12-21-2021
Meeting Minutes
6:30 PM

Re: Northeast Pond Condominium; Engineering Review Response Letter 10-4-21

Subject: Map 023 / Lots 040 and 044 – Northeast Pond Condominium
Engineering Review

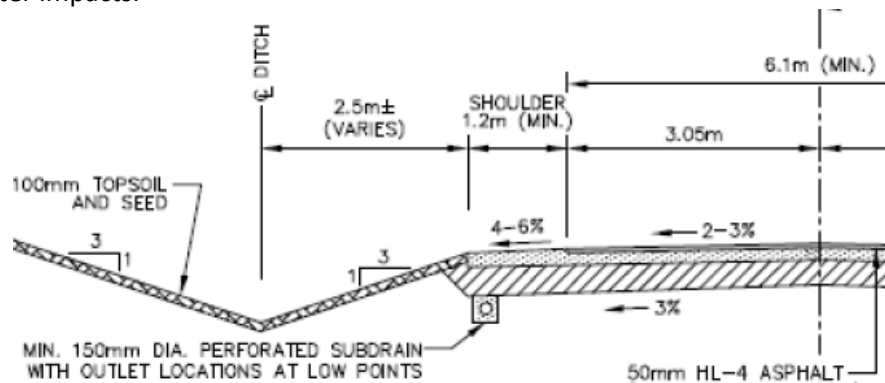
In review of the typical driveway cross-section, the 6-inch underdrain is graphically illustrated not under and at the outer limits of the subbase materials; see on Sheets C-5 and C-7. Roadway underdrains are typically located as illustrated below to allow the gravels to drain and mitigate groundwater impacts.

Response: The typical cross-section detail has been revised so the 6-inch underdrain is located at the outer limits of the subbase material. See sheet C-5 and C-7.
